DESCRIPTIVE REPORT

Registry No. H-10987

General Locality TONGASS NARROWS

Sublocality Ketchikan to 1/2 NM SE of Lewis Point

Table D.2.1

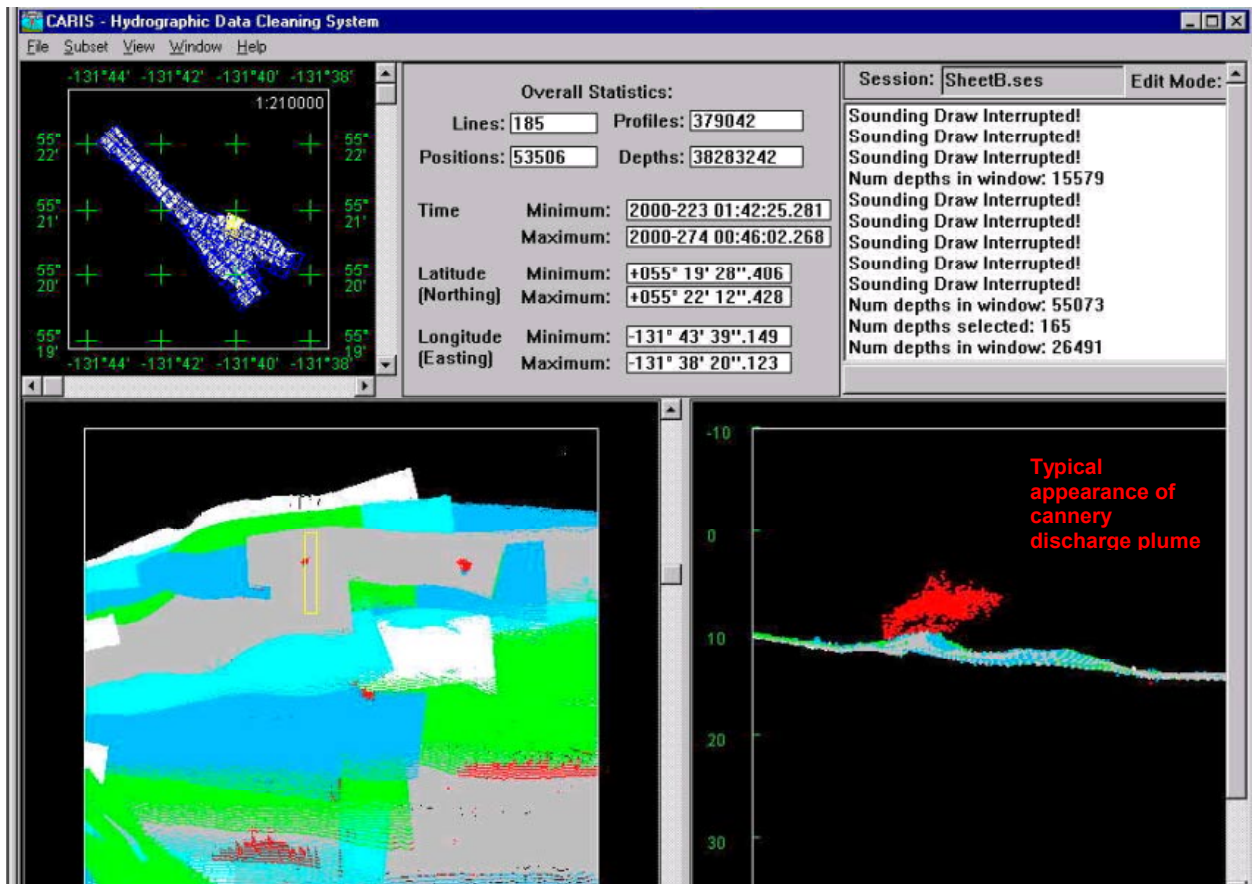
Aids to navigation in the survey area, shown in Table D.2.1, served their intended purpose and their characteristics matched those given in the Chart and Light List. New, previously uncharted aids found in the survey were a fixed green light at latitude 55° 20' 17.68" north and longitude 131° 38' 36.06" west, and a fixed red light at latitude 55° 20' 28.81" north and longitude 131° 38' 51.79" west. These two navigation aids, located on the Ketchikan cruise ship pier, were designated Items to Be Investigated. Further information is given in Table D.2.3, New Features.³⁹ Complete information about these items is provided in the MapInfo database under Workspace file Ketch_ITBI.wor.⁴⁰

⁴¹ It is recommended that these aids to navigation be charted with the most recent information from the US CG. District 17.

Caris screenshot showing typical plume of material from cannery discharge

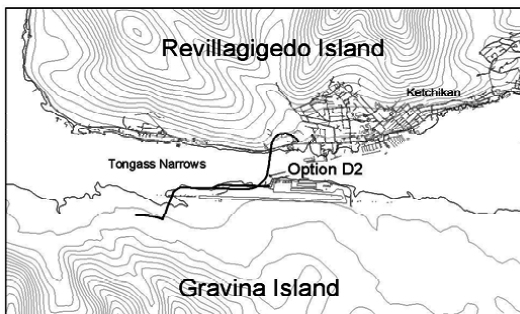
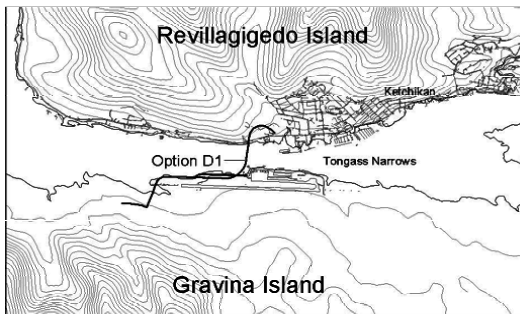
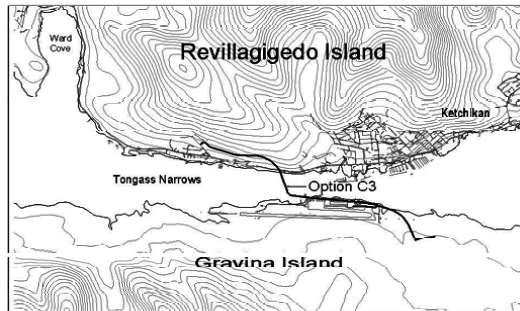
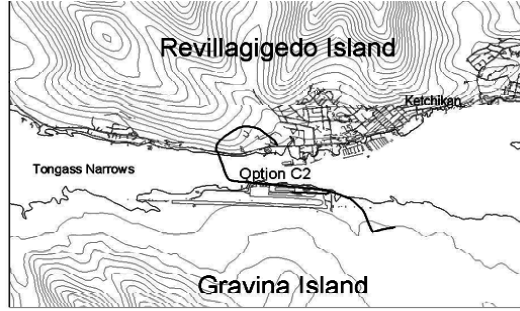
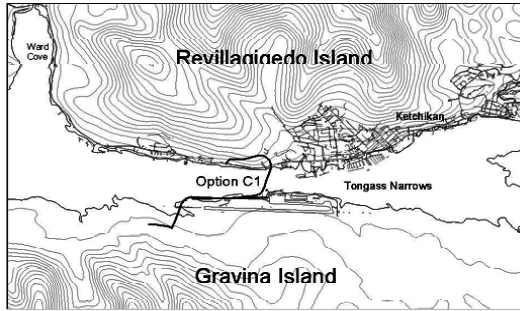
A number of uncharted items were discovered during the Shoreline Verification of the area, including new floating docks and other structures of practical value to mariners. New features are discussed above and in detail in the table later in this section.⁴⁴ No new information of significant scientific value resulted from the survey. Anomalous tidal conditions were not encountered. Environmental conditions bearing directly on the hydrographic data included the presence of bull kelp throughout many areas shoreward of the four-meter curve, as well as some areas seaward of the four-meter curve. Kelp beneath the sonar head may have caused occasional interference in bottom acquisition; however, in general such interference is readily detectable in processing. In some areas, discharge from cannery outflows created plumes of material in the water column. Investigation of plumes with multibeam and side scan led project hydrographers to conclude that the material load in these areas was transitory, rather than an indicator of true seafloor bottom. However, “mounds” at the same locations are assumed to be accumulated cannery discharge that may remain on the seafloor for an indefinite time.⁴⁵

-
- ⁴⁵ Chart soundings according to the smooth sheet.
- ⁴⁶ Do not concur, this area should be resurveyed at an interval appropriate to local conditions and available resources. See National Survey Priorities 2004.
